Docket No. 348
No. 364

JOSEPH M. FARLEY NUCLEAR PLANT UNITS 1 AND 2
EMERGENCY PROCEDURES AND TRAINING FOR
STATION BLACKOUT EVENTS

Emergency Procedures and Training For Station Blackout Events

DIAGRAM 1

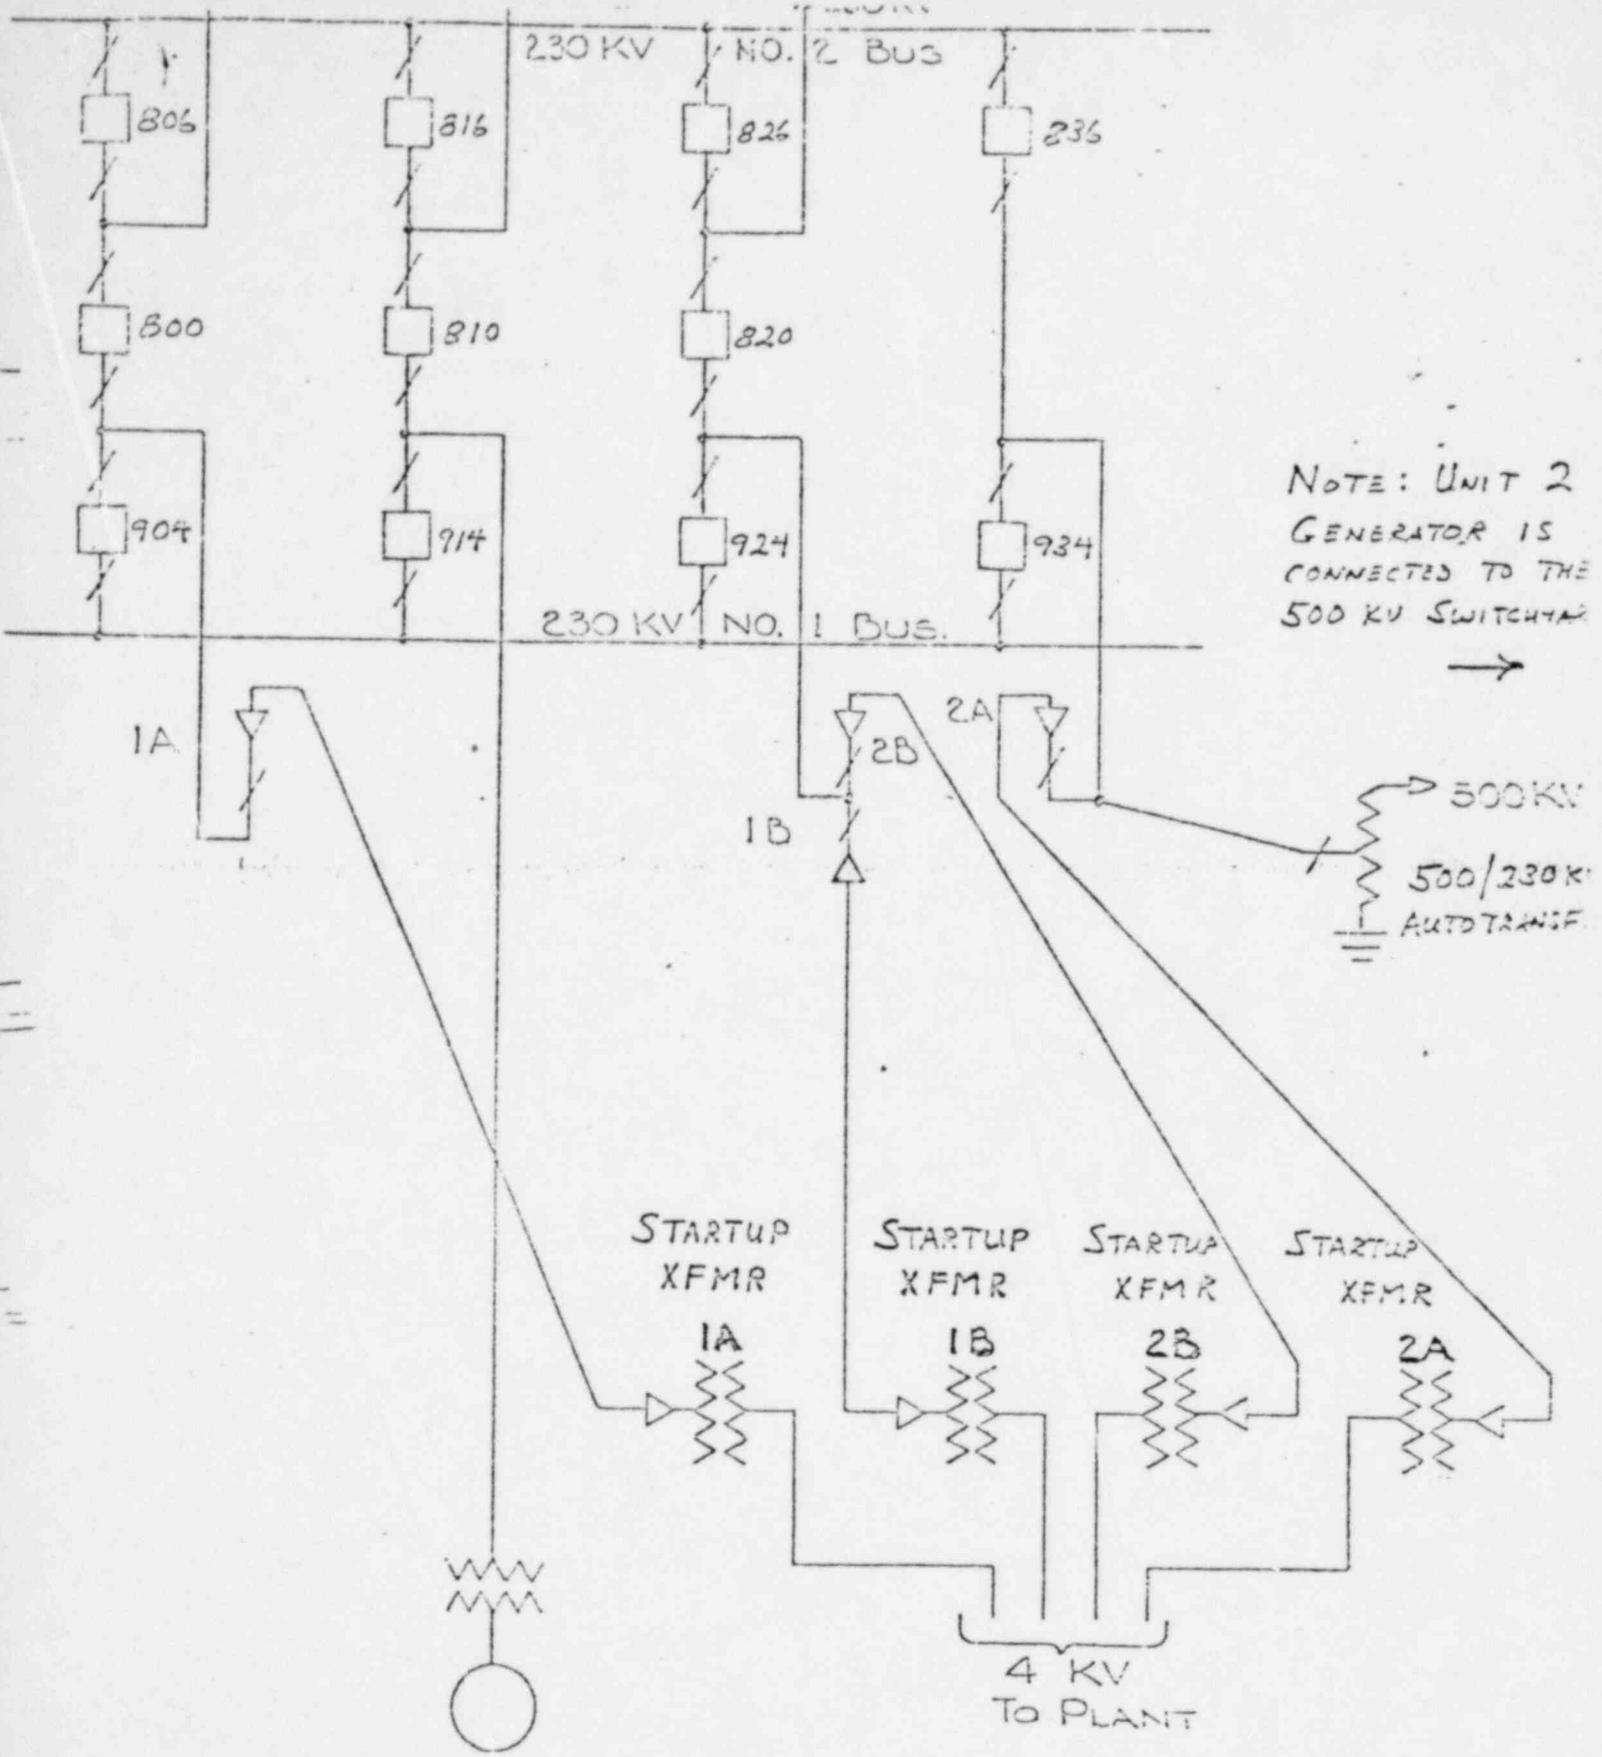
- a. The actions necessary and equipment available to maintain the reactor coolant inventory and heat removal with only DC power available, including consideration of the unavailability of auxiliary systems such as ventilation and component cooling.

- b. The estimated time available to restore AC power and its basis.
 - c. The actions for restoring offsite AC power in the event of a loss of the grid.

Meanwhile, power would be restored to the grid and Farley substation by the Alabama Power Company "Wide Area Blackout Emergency Procedure" which is currently being utilized. This procedure provides general guidance and a specific and orderly plan of action for restoring AC power to the grid in the event of blackout. The initial objective is to utilize all available generation (combustion turbines and hydro units) to restore station service to all steam plants including Plant Farley. The following summarizes the specific instruction applicable to the Farley Nuclear Plant. (Refer to the attached Diagram 1):

- 1) Breakers 914, 934, 836, 826, 816, 810, and 820 will be opened. Breakers 800, 904, and 924 will be closed.
- 2) The Pinckard 230 KV line will be energized from the Montgomery Switching Station. This will energize the Farley No. 1 230 KV bus and the No. 1A, 1B, and 2B Startup Transformers.
- 3) Once the No. 1 Bus is energized, breaker 934 will be closed to pick up Startup Transformer 2A and the 500/230 KV auto-transformer.
